| APPLICATION NO. | FILING DATE | FIRST NAMED INVENTOR | ATTORNEY DOCKET NO. | CONFIRMATION NO | |
|--|----------------|------------------------|-----------------------------|-----------------|--|
| 10/632,433 | 07/31/2003 | William Andrew Decanio | HI02001USU1 (P01018USU1) | 2856 | |

DETAILED ACTION

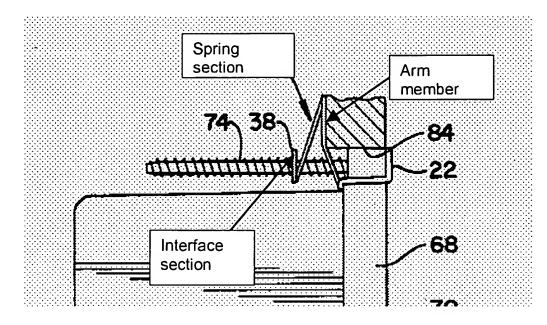
Claims 3-23, 25, and 26 are rejected under 35 U.S.C. 102(b) as being anticipated by Suk (US patent no. 4,120,473). Suk disclosed all the claimed features of applicant's invention (see illustration below). Suk further shows a spring section interconnect the arm with the interface section (38) with bore (40) receiving shaft (74) wherein the arm is pivotally coupled to the interface section via the spring section (where pivot axis is through page) and wherein the attachment edge is toothed surface (48, figure 5).

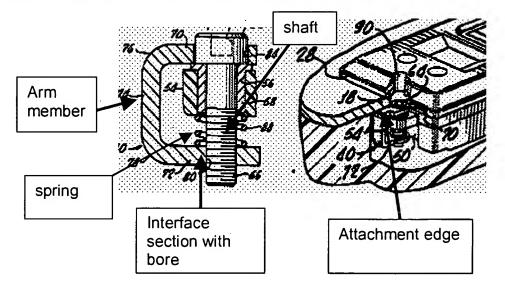
Claims 13-21, 23, and 25 are rejected under 35 U.S.C. 102(b) as being anticipated by Stange et al (US patent no. 5,374,103). Stange disclosed all the claimed features of applicant's invention (see illustration below).

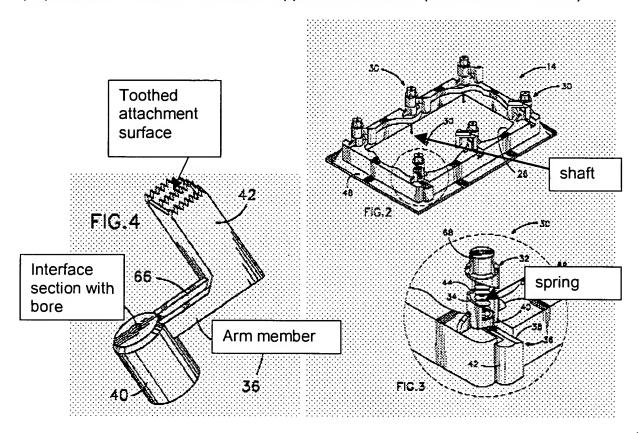
Claims 13-25 are rejected under 35 U.S.C. 102(e) as being anticipated by Tchilinguirian (US patent no. 6,588,543). Tchilinguirian disclosed a speaker housing (48) with all the claimed features of applicant's invention (see illustration below).
